**RE: Snow Vista Self Storage
Conceptual Grading and Drainage Plan
Engineer's Stamp Date: 09/27/23
Hydrology File: M09D012B**

**RE: 98TH & SAGE STORAGE
CONCEPTUAL GRADING AND DRAINAGE PLAN
RESPONSE TO COMMENT**

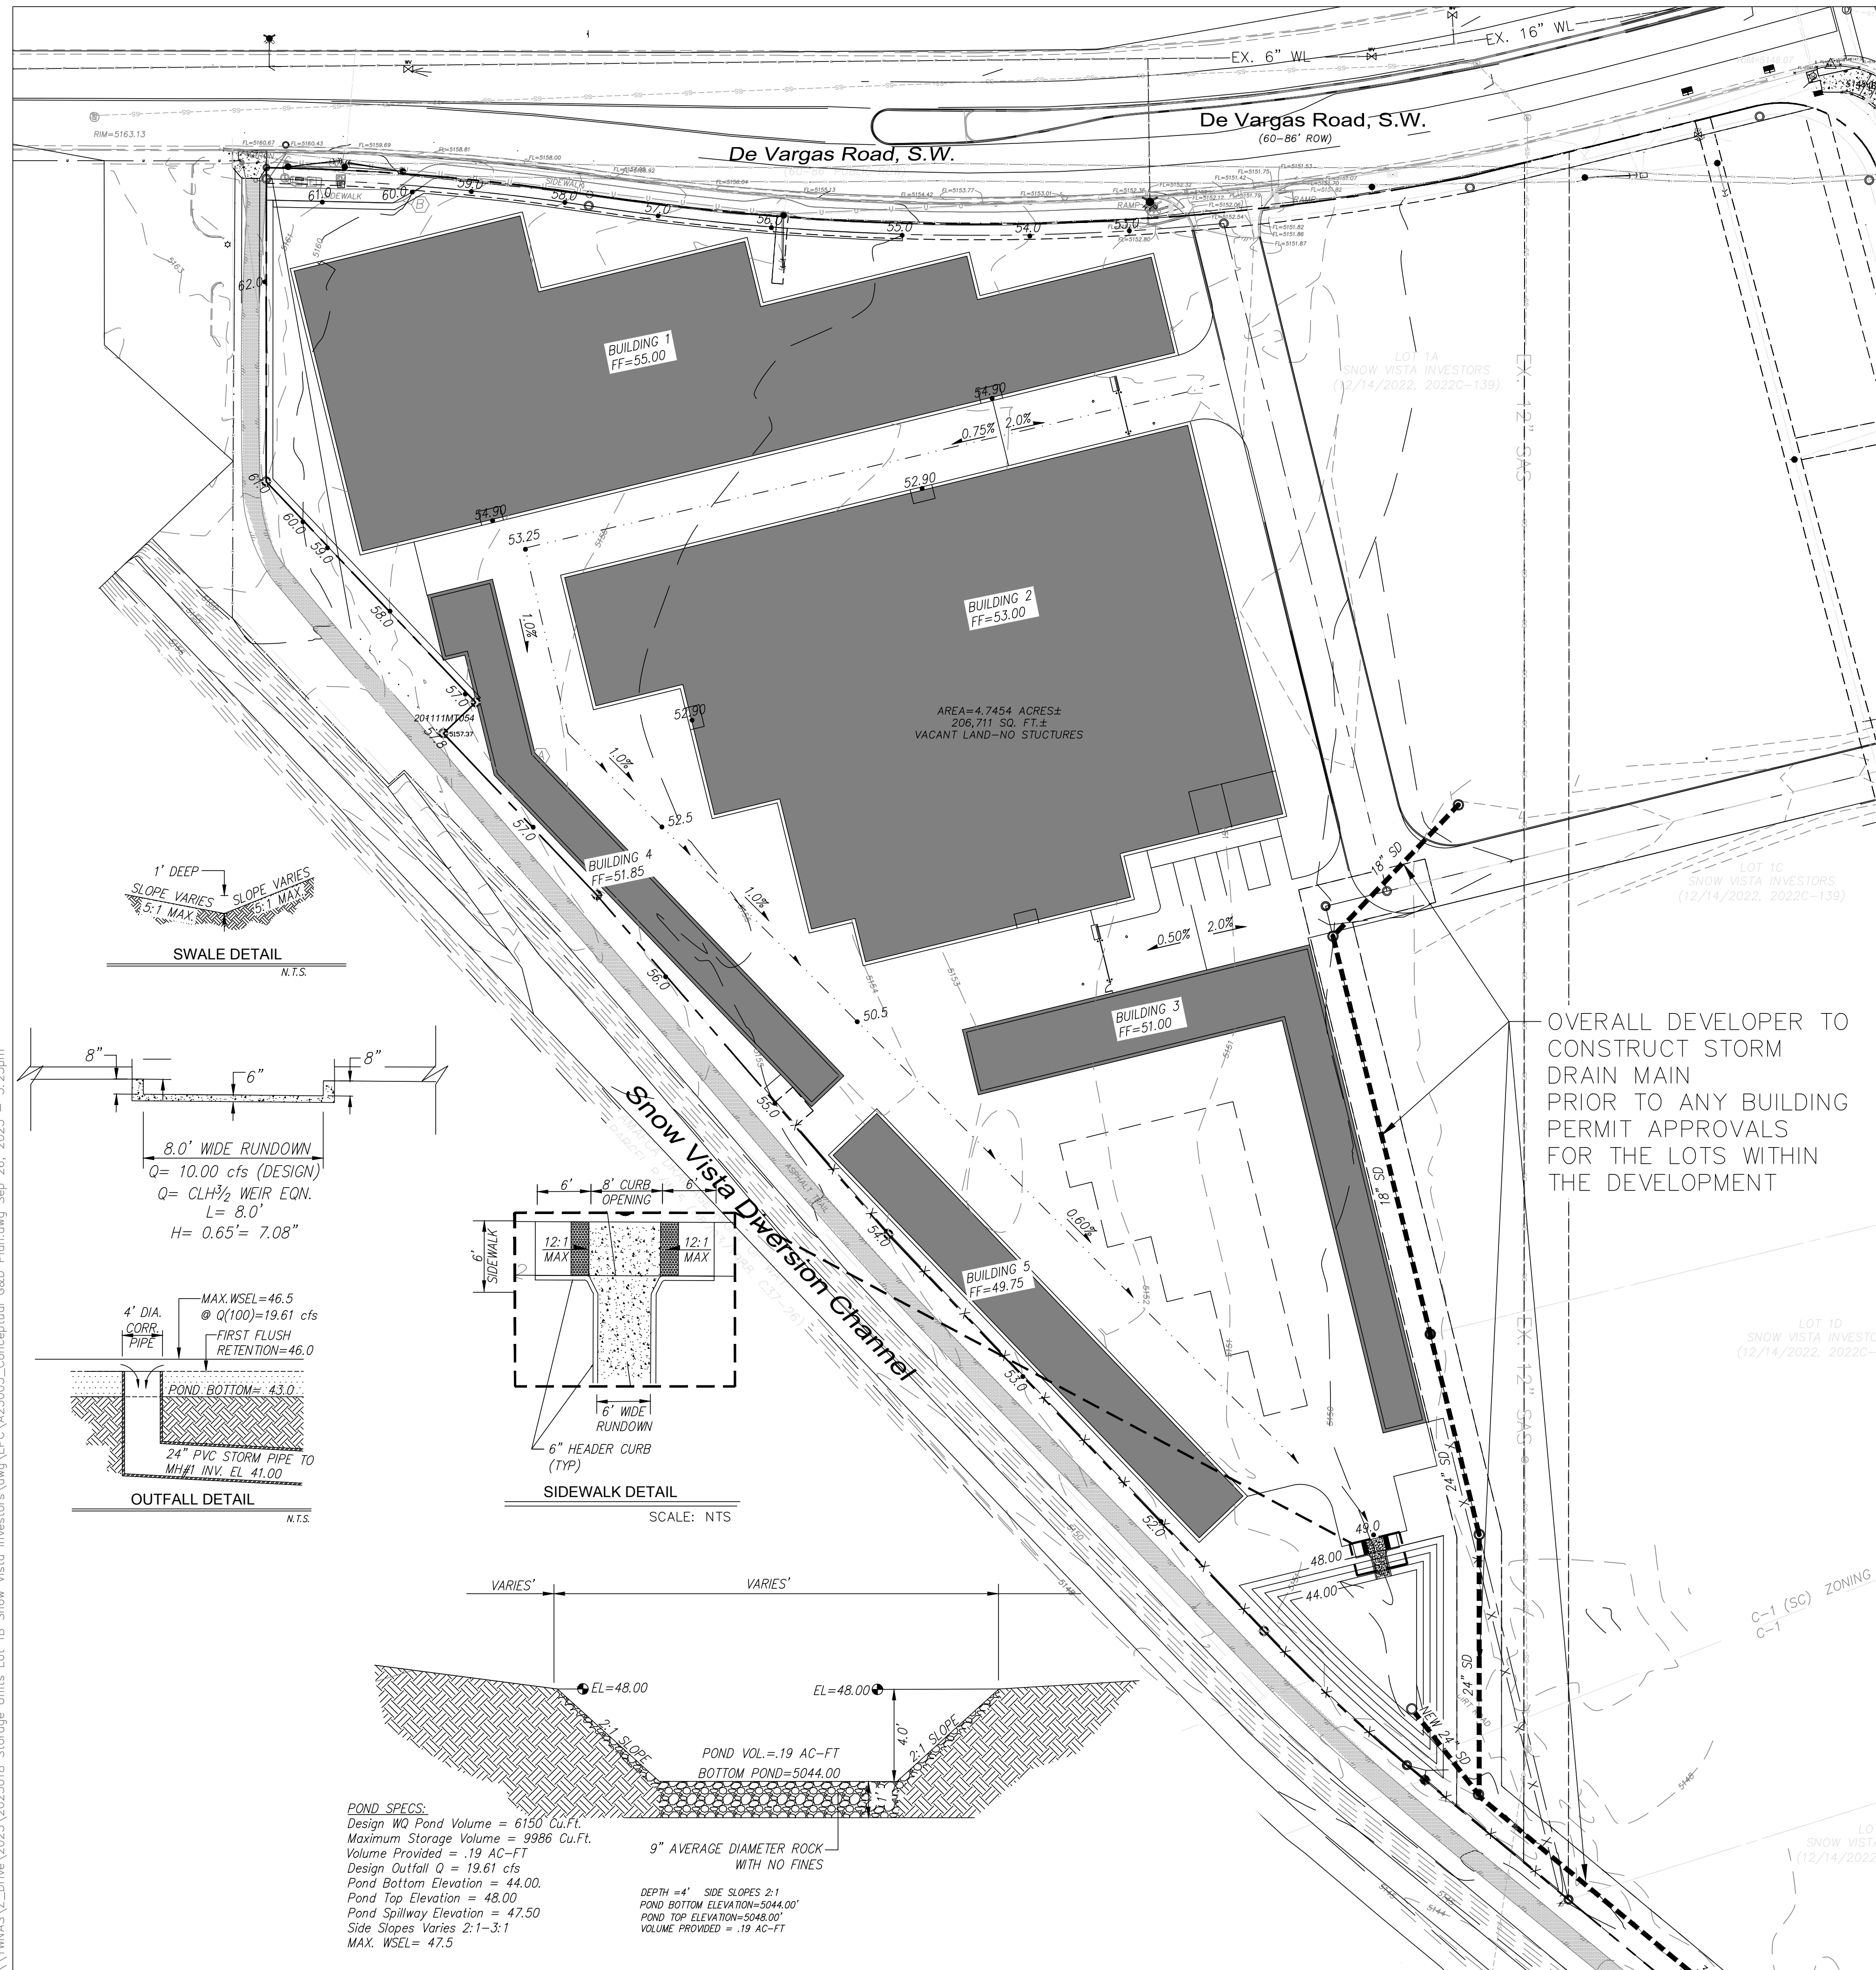
1. Please remove all the stormwater quality ponds around Building 1. All of these are on the High side of the development and will not capture any stormwater. Please make sure that the southeast pond is.

Response: Storm water quality ponds around Building 1 have been removed. Southeast pond is sized to contain the water quality volume.
2. Please show the storm pipe that was approved for the overall development on July 20, 2023. Please label as "Overall Developer to construct prior to any further Building Permit approvals for the lots within the development."

Response: Storm drain added and noted as directed.
3. Please either consolidate the drainage calculations and the details to GR-2 and rename to GR-1 or change the scale on GR-1 to 1"-40'.

Response: Changed scale on GR-1.
4. Please change the Title of the sheet to "Conceptual Grading and Drainage Plan."
Response: See updated GR-1 plan.
5. Please add the note, "Not for Construction."

Response: See updated GR-1 plan.
